CC Docket No. 93-268

**TIA's COMMENTS**

**User Premises Equipment Division of  
the Telecommunications Industry  
Association**

February 10, 1994

Figure 68.308 (e) Ref. EJA/TIA 547-1989)  
Isolated Pulse Template and Corner Points for 1.544 Mbps equipment

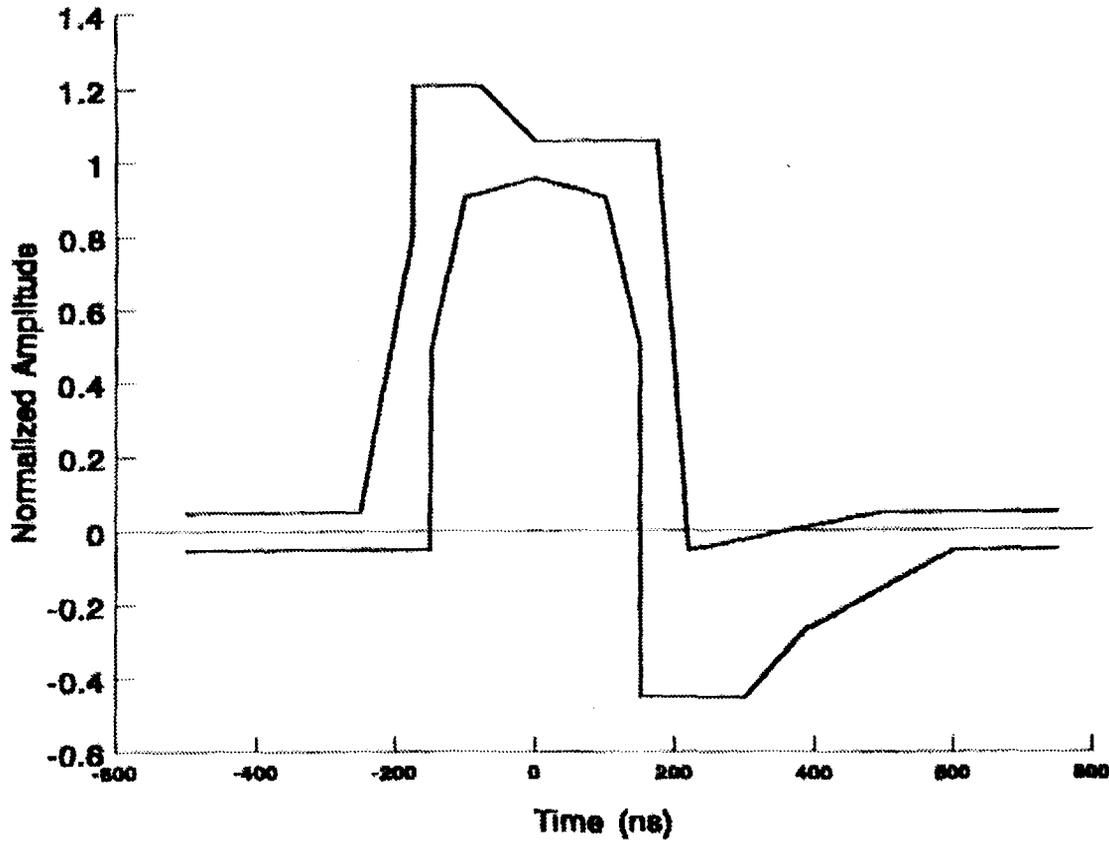
Section 68.308(h)(2) must be modified in the Title and other appropriate paragraphs to also refer to ISDN Primary Rate Access ("PRA") wherever there is a reference to 1.544 Mbps service. In addition, TIA recommends that the pulse template specified in Table III be modified to allow a maximum pulse height of 3.6 Volts and for the Option A pulse to fall within the template shown in Attachment A to these Comments. These changes would also apply to 1.544 Mbps service and are consistent with the industry-adopted standards for these services in both the U.S. and Canada. (See, for example, ANSI/EIA/TIA 547-1989)

Note: The pulse amplitude is 2.4 to 3.6 V. (Use constant scaling factor to fit normalized template.)
